BARANGAROO SOUTH

Stage 1B Public Domain Modification S4.55

Project
BARANGAROO STAGE 1B
PUBLIC DOMAIN
Modification S4.55

Drawing Title
WATERMANS COVE
MASTERPLAN - NO TREES
Drawn
SS

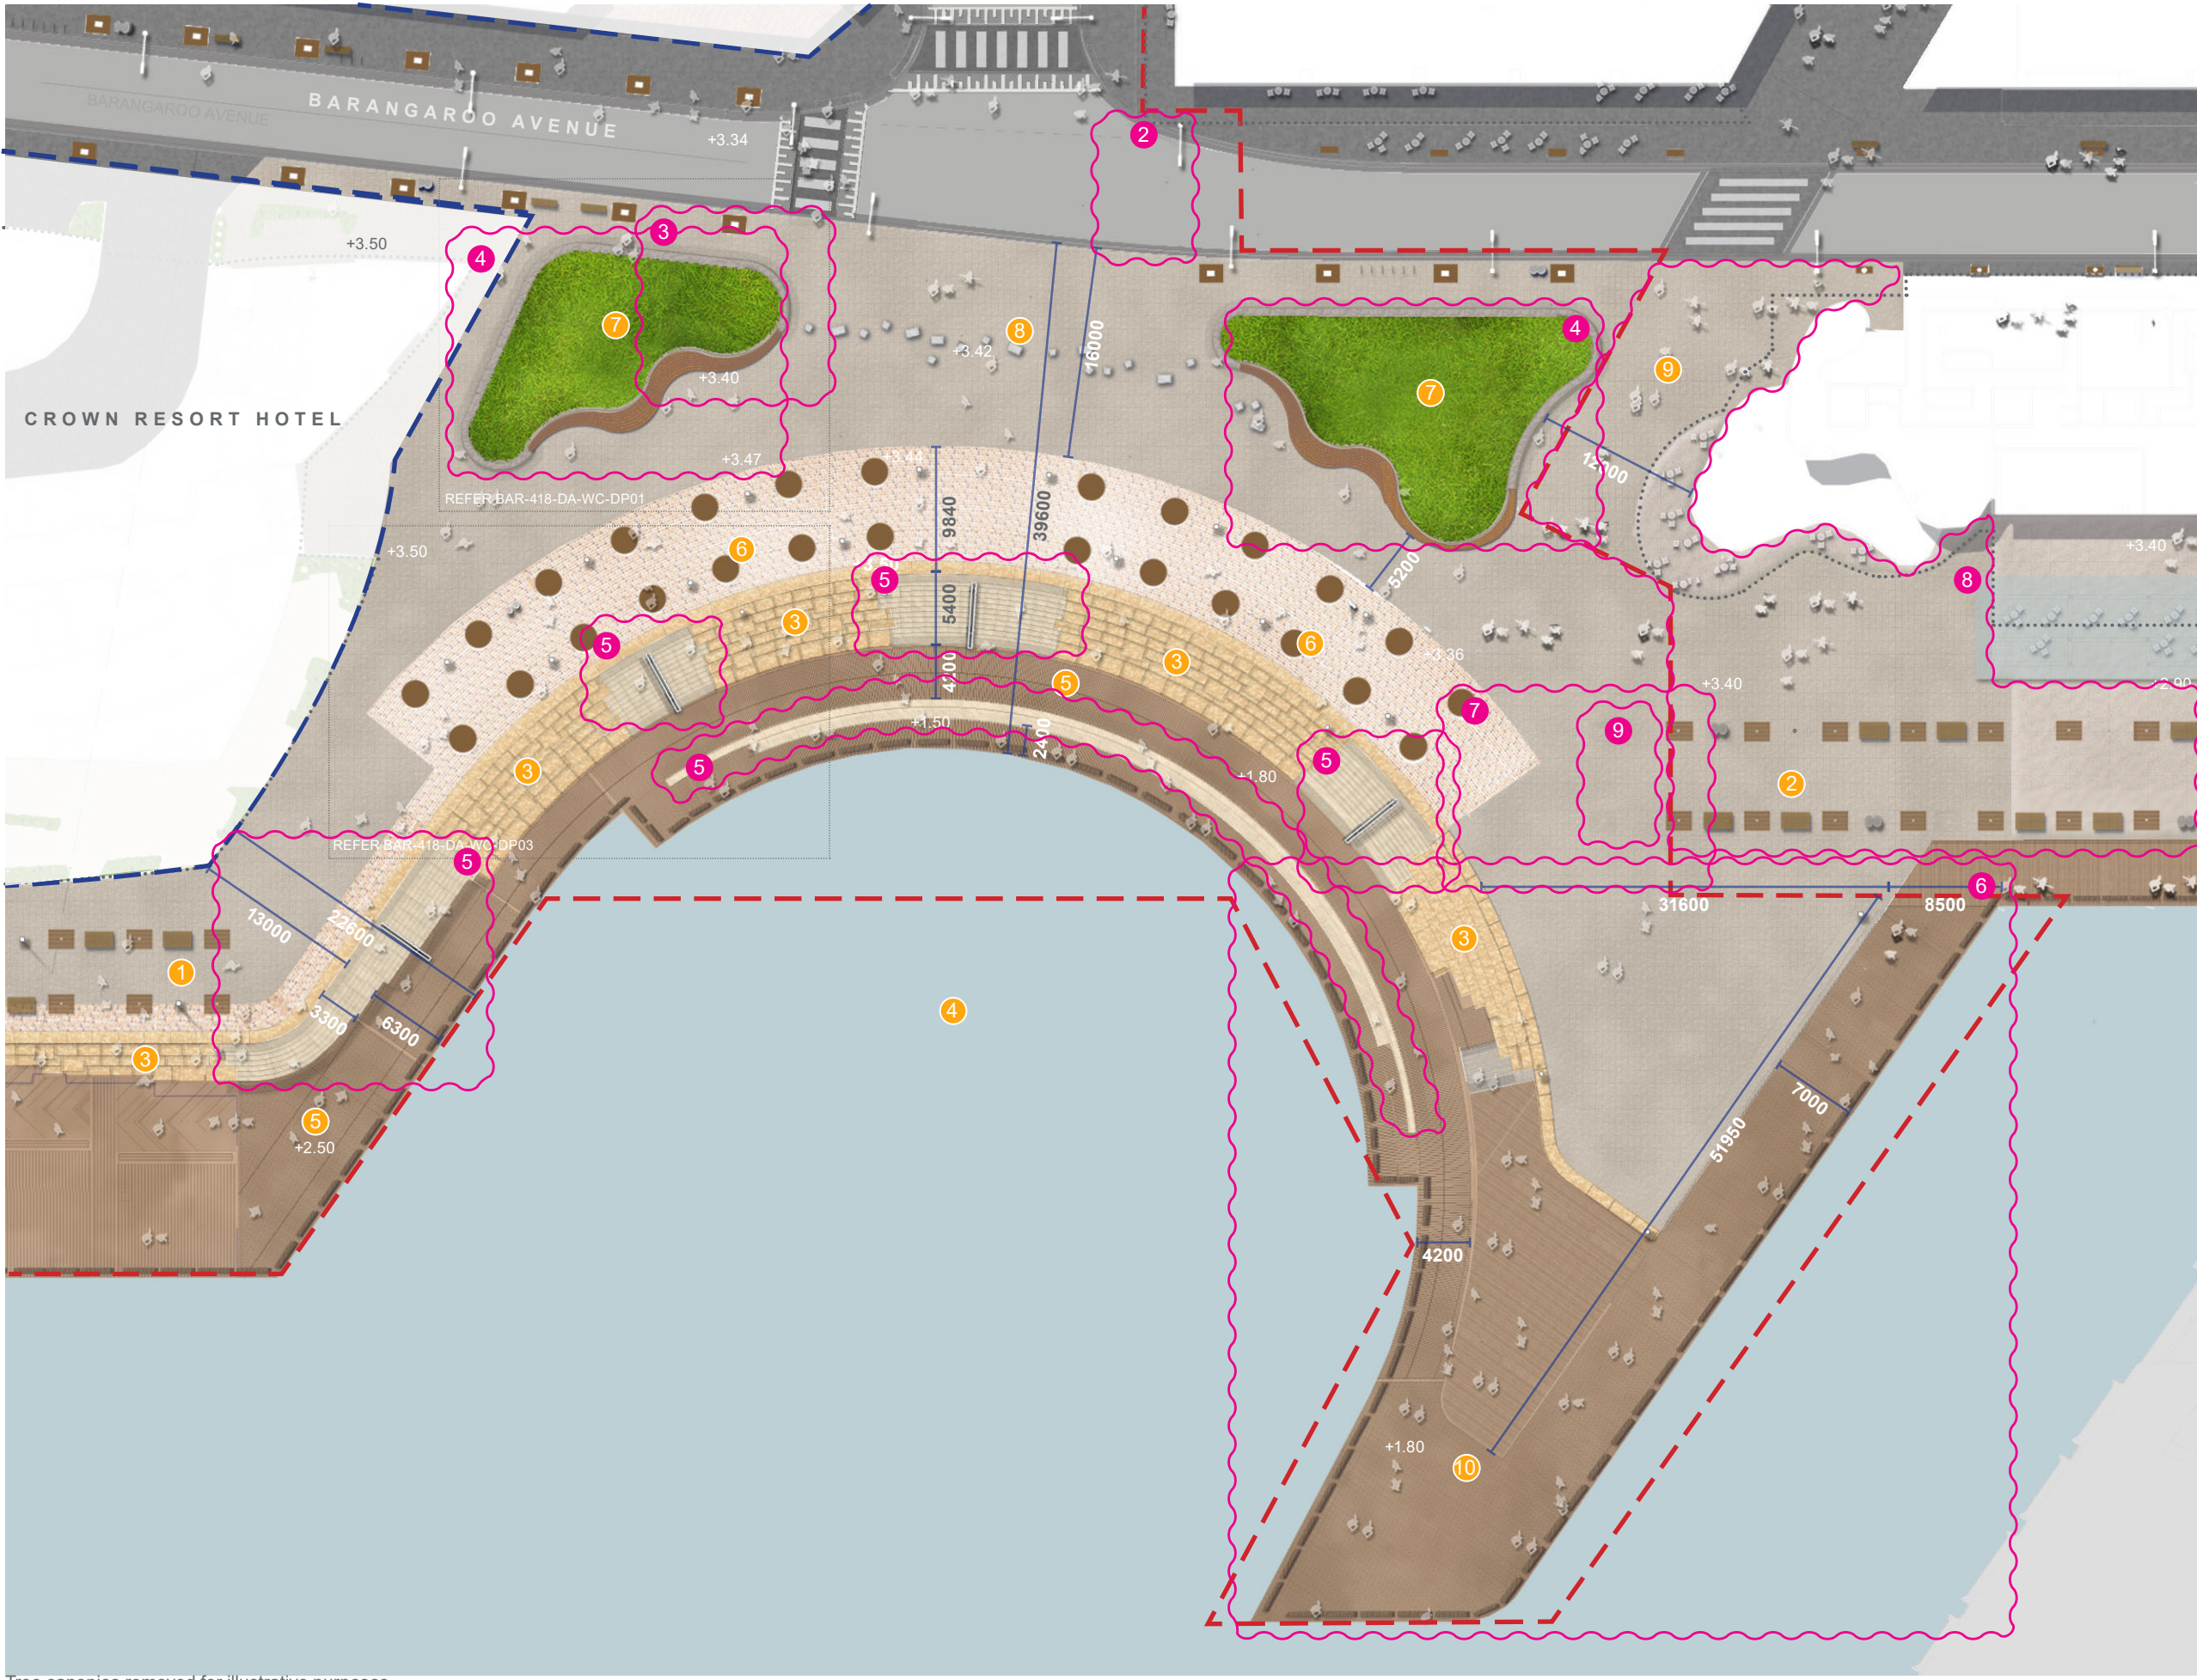
- Amendment cloud
- 1 Not in use
- 2 Deletion of pedestrian crossing
- 3 Relocated Fig tree to North raised planter
- 4 Change geometry of raised planter/reduce raised planter timber top and remove timber backrest
- 5 Stone stairs changed to concrete
- 6 Pier re-design: change to 3 tiers design
- 7 Stop porphyry paving at the top of the last Southern stair
- 8 Stage 1A design modification to suit Stage 1B proposal. Subject to separate approval.
- 9 Removal of 2no. Celtis australis to respond to pier amendment

Drawing Title
WATERMANS COVE
TERRACED SEATING DETAIL
PLAN - TREES
Drawn
SS

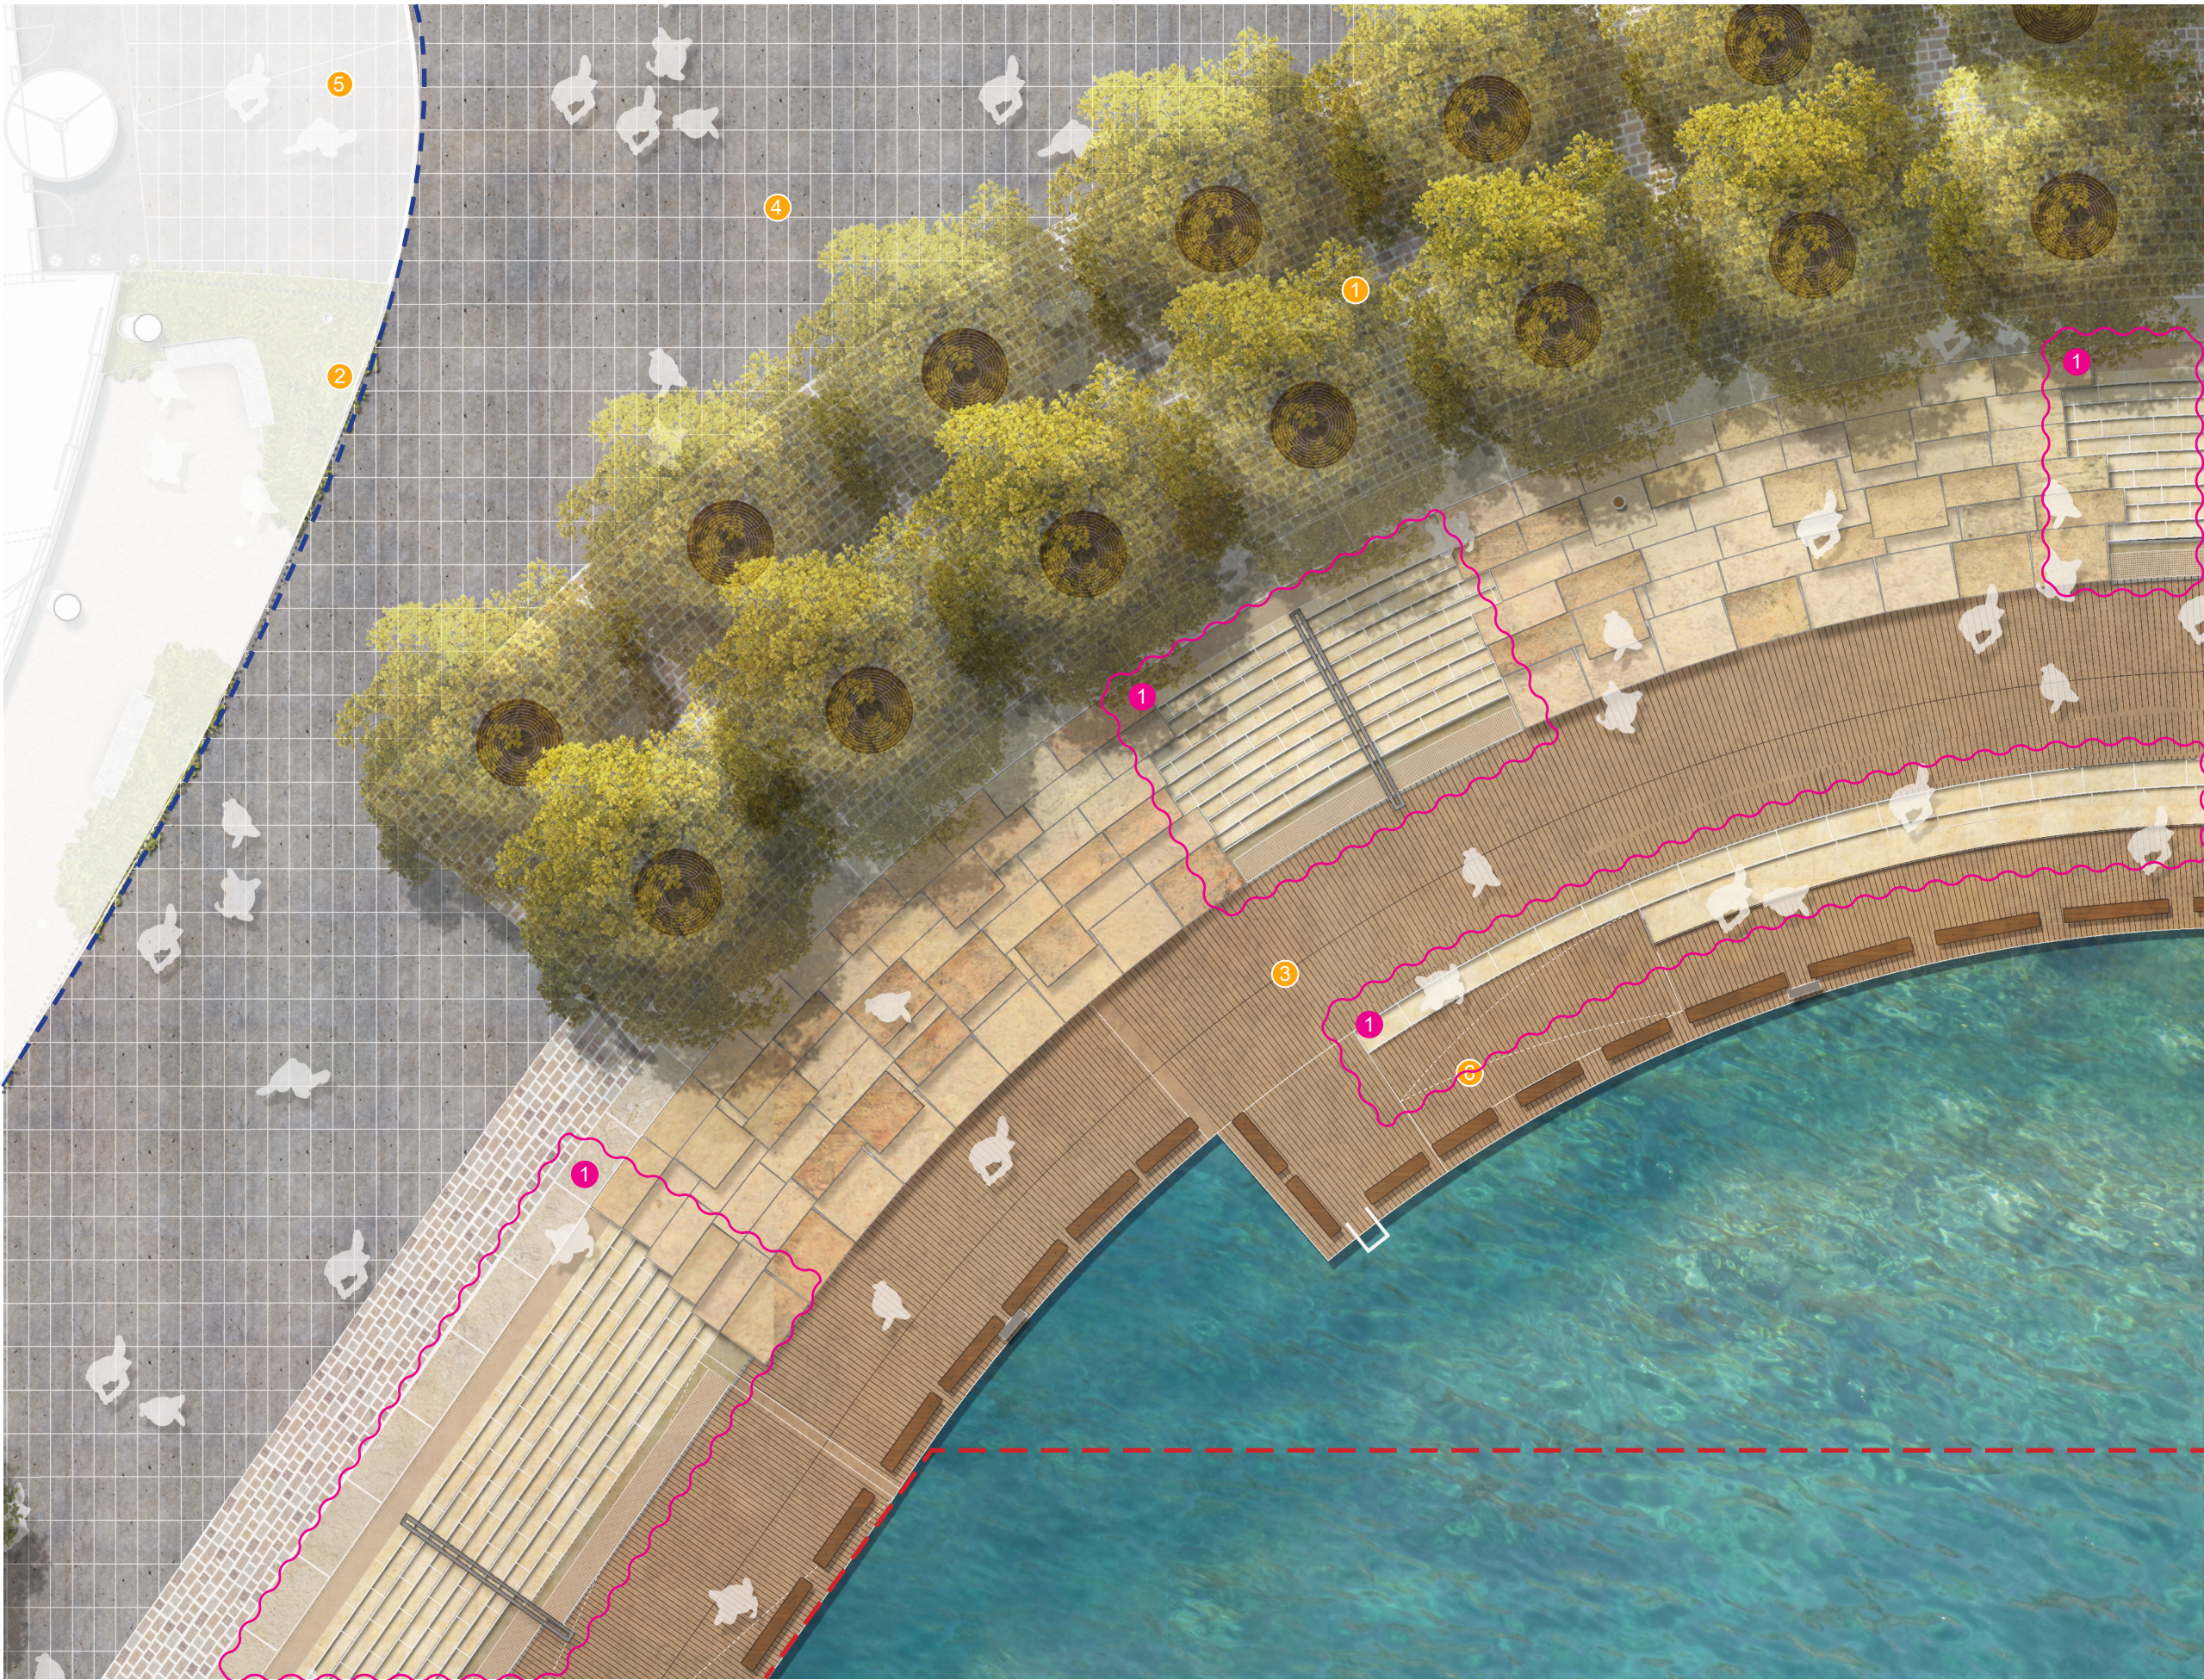
- Amendment cloud
- 1 Stone stairs changed to concrete

Drawing Title
WATERMANS COVE
TERRACED SEATING DETAIL
PLAN - NO TREES
Drawn
SS

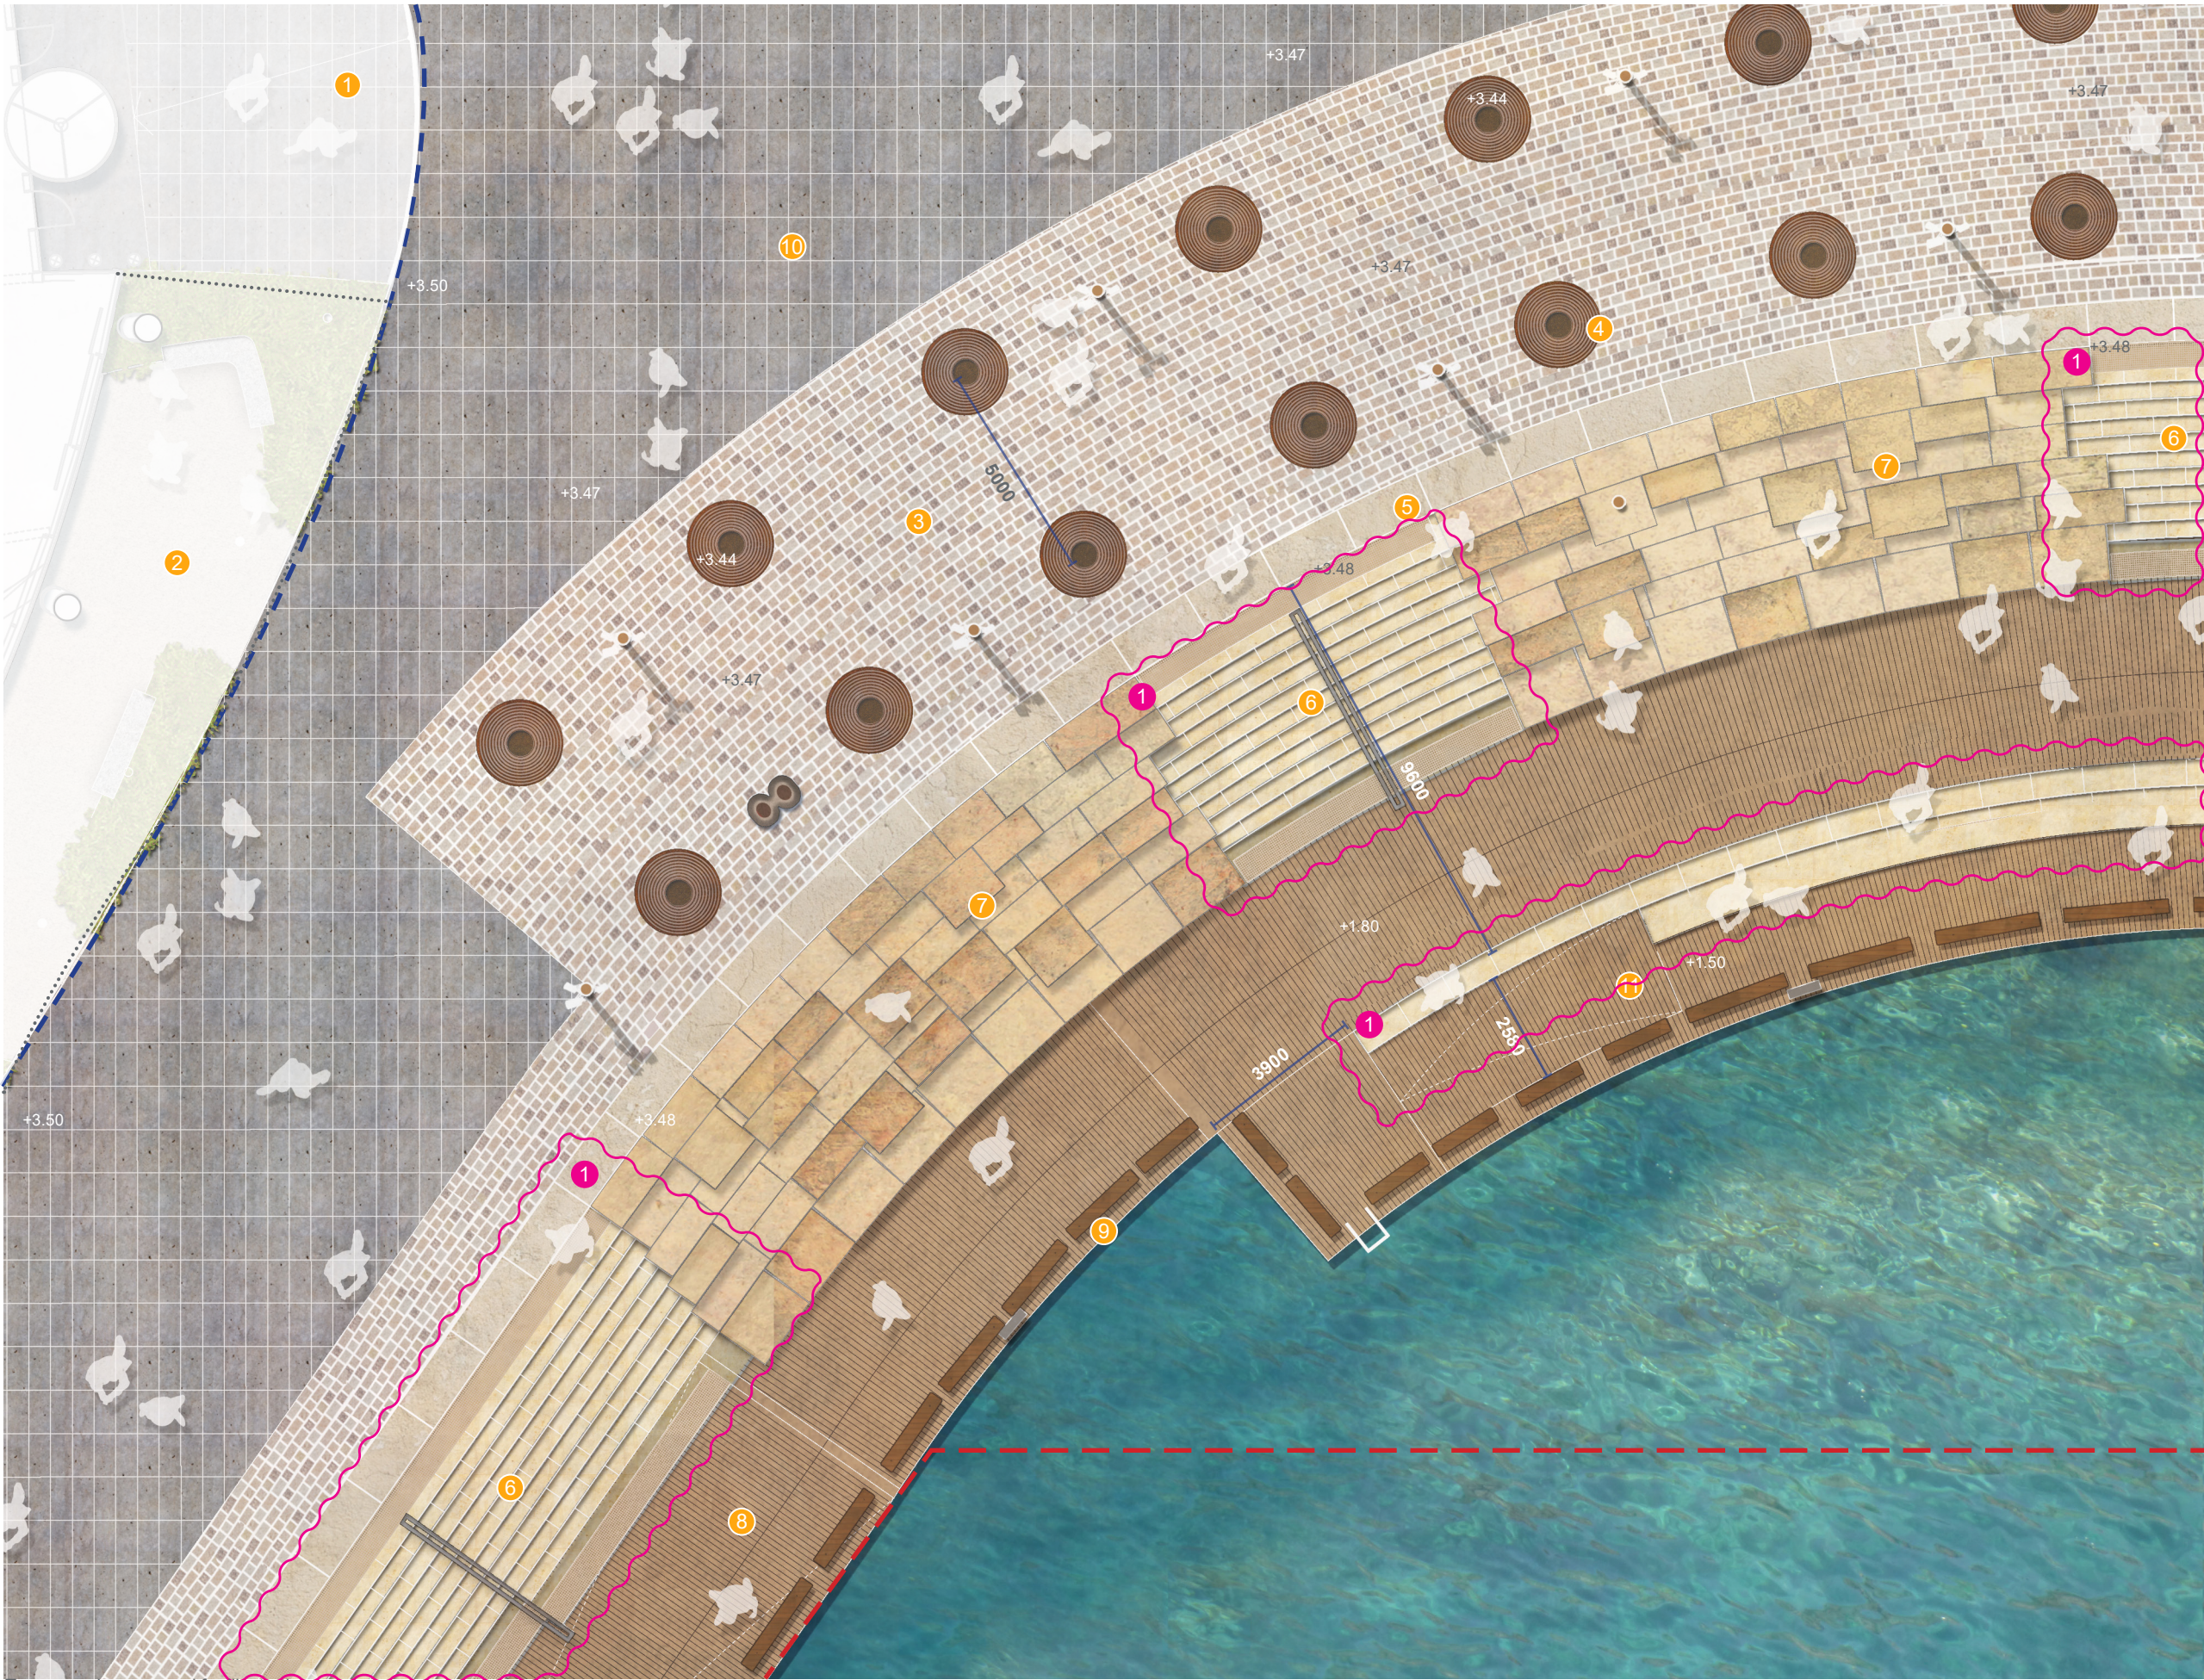
- Amendment cloud
- 1 Stone stairs changed to concrete
